# Ballast Water Management Systems

Rules/Guidance for Ballast Water Management Installations

ID:DX25-09

Amended-Original Requirements Comparison Table (Ballast Water Management Systems)

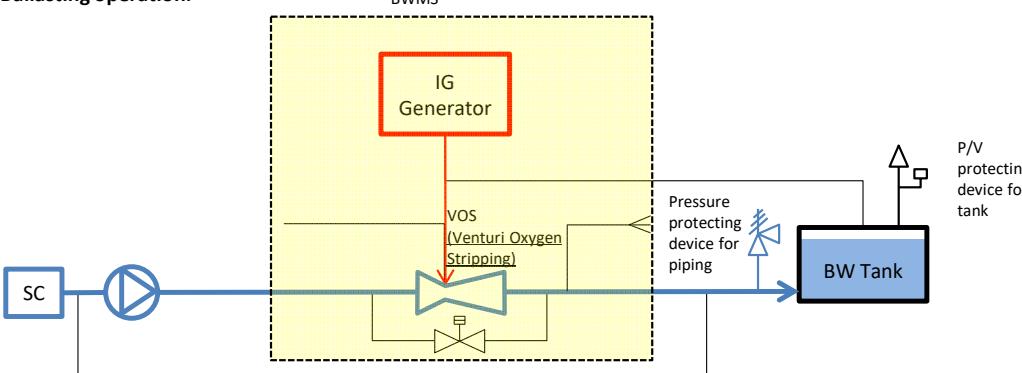
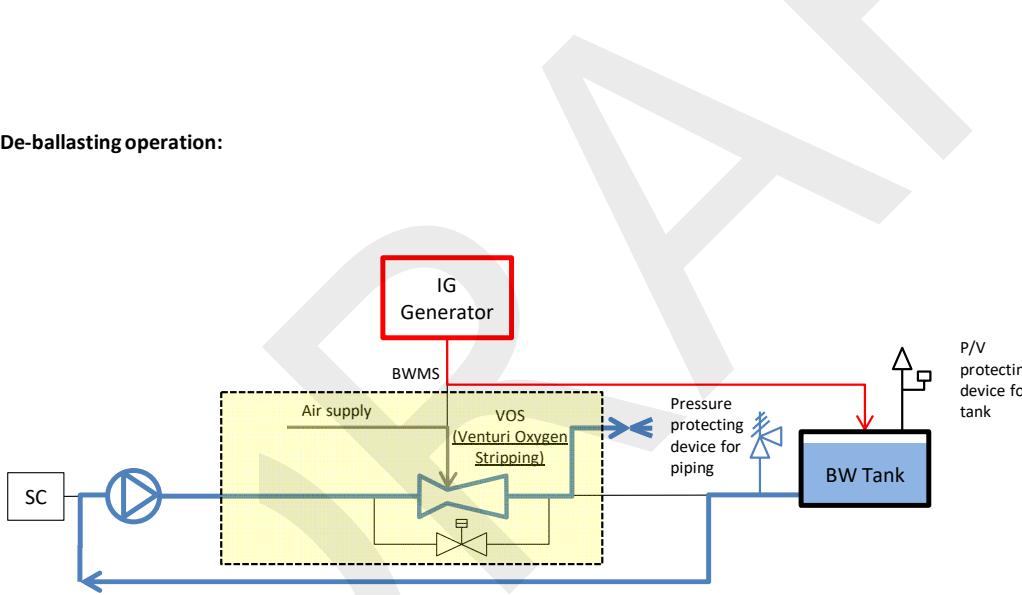
Amended	Original										Remarks		
<i>BWMS technology category →</i>	1	2	3a	3b	3c	4	5	6	7a	7b	8	UR M74 (Rev.3) Table of TB file	
Requirements ↓	Table 2.1.1-2 Applicability of the Requirements for Each <i>BWMS</i> Technology Category												
2.2.1	X	X	X	X	X	X	X	X	X	X	X		
2.2.2			X	X	X							X	
2.2.3-1 and -2				X	X					X	X		
2.2.3-1 and -3 to <del>65</del>						X	X	X					
2.2.3- <del>76</del> and <del>87</del>	X	X	X	X		X	X	X	X	X	X		
2.2.3- <del>98</del> to <del>1413</del>	X	X	X	X	X	X	X	X	X	X	X	X	
2.2.3- <del>14</del> to 2.2.3- <del>16</del>	X	X	X	X		X	X	X	X	X	X		
2.2.4-1(1)		X	X			X	X	X	X	X	X	X	
2.2.4-1(2)			X	X	X					X	X	X	
2.2.4-1(3)										X	X		
2.2.4-1(4)						X	X	X	X	X	X		
2.2.4-1(5)						X	X	X					
2.2.4-1(6)			X	X	X				X	X	X

Fig. 2.2.3-1 Means of Appropriate Isolation

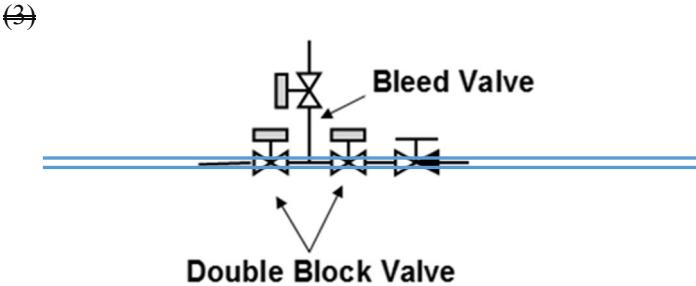
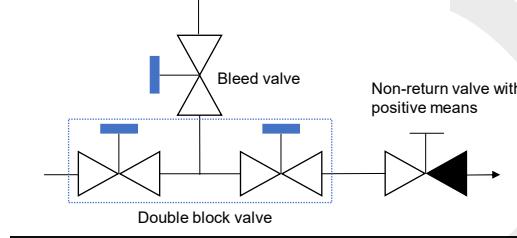
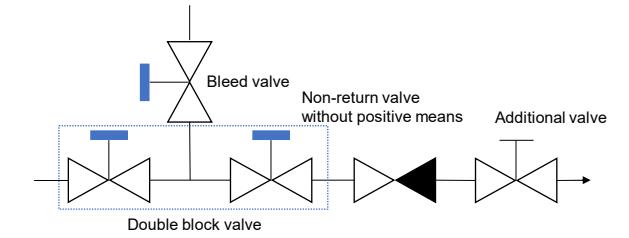
Amended	Original	Remarks
<p>additional valves having such means of closing may be provided between non-return valves and spool pieces (<u>Fig. 2.2.3-1(2)</u>).</p> <p>(2) Two non-return valves with positive means of closing in series with liquid seals at least 1.5 m in depth (<u>Fig. 2.2.3-1(3)</u>). As an alternative to such positive means of closing, additional valves having such means of closing may be provided between non-return valves and liquid seals (<u>Fig. 2.2.3-1(4)</u>). For ships operating in cold weather conditions, freeze protection is to be provided for water seals (portable heating systems may be accepted for this purpose).</p> <p>(3) Automatic double block and bleed valves and non-return valves with positive means of closing (<u>Fig. 2.2.3-1(5)</u>). As an alternative to such positive means of closing, additional valves having such means of closing may be provided after non-return valves (<u>Fig. 2.2.3-1(6)</u>).</p>	<p>additional valves having such means of closing may be provided between non-return valves and spool pieces.</p> <p>(2) Two non-return valves with positive means of closing in series with liquid seals at least 1.5 m in depth (<u>Fig. 2.2.3-1(2)</u>). As an alternative to such positive means of closing, additional valves having such means of closing may be provided between non-return valves and liquid seals. For ships operating in cold weather conditions, freeze protection is to be provided for water seals (portable heating systems may be accepted for this purpose).</p> <p>(3) Automatic double block and bleed valves and non-return valves with positive means of closing (<u>Fig. 2.2.3-1(3)</u>). As an alternative to such positive means of closing, additional valves having such means of closing may be provided after non-return valves.</p>	<p>UR M74 (Rev.3) para.3.2.3.1.1, 3.2.3.1.2 and 3.2.3.1.3</p> <p>The current figures (1) to (3) are replaced with new figures (1) to (6).</p>

<p><u>(1) Means of appropriate isolation for 2.2.3-9(1)</u></p> 	<p><u>(2) Alternative to positive means for 2.2.3-9(1)</u></p> 	
<p><u>(3) Means of appropriate isolation for 2.2.3-9(2)</u></p> 	<p><u>(4) Alternative to positive means for 2.2.3-9(2)</u></p> 	
<p><u>(5) Means of appropriate isolation for 2.2.3-9(3)</u></p> 	<p><u>(6) Alternative to positive means for 2.2.3-9(3)</u></p>

Table 2.2.3-1 In-line BWMS Technology Categorization  
(Does not cover categories 3c and 8)

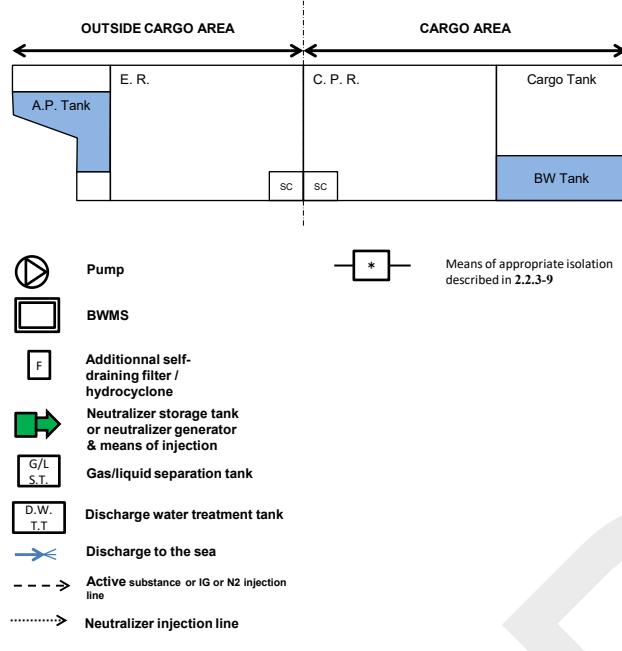
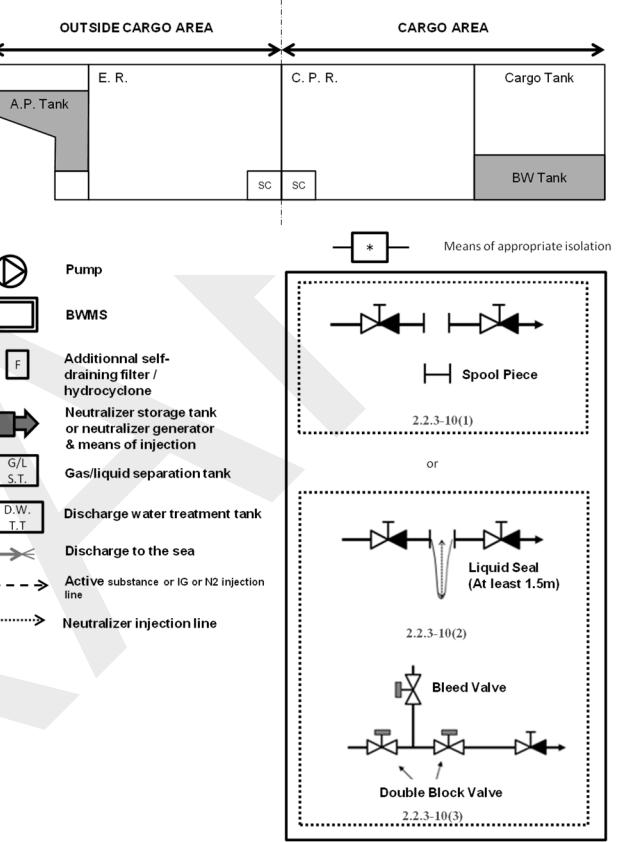
Amended		Original										Remarks
Disinfect on when ballasting	Characteristics ↓	1	2	3a	3b	4	5	6	7a	7b		
	Making use of active substance		X									
	Full flow of ballast water is	X	X	X	X	X	X

BWMS technology category →	1	2	3a	3b	4	5	6	7a	7b
In-line UV, UV with advanced oxidation technology (AOT), UV with TiO <sub>2</sub> or UV with plasma									
In-line flocculation									
In-line membrane separation and de-oxygenation (injection of N <sub>2</sub> from N <sub>2</sub> generator)									
In-line de-oxygenation (injection of inert gas from inert gas generator)									
In-line full-flow electrolysis									
In-line side-stream electrolysis <sup>(3)</sup>									
In-line (stored) chemical injection									
In-line side-stream ozone injection without gas/liquid separation tank and discharge water treatment tank									
In-line side-stream ozone injection with gas/liquid separation tank and discharge water treatment tank
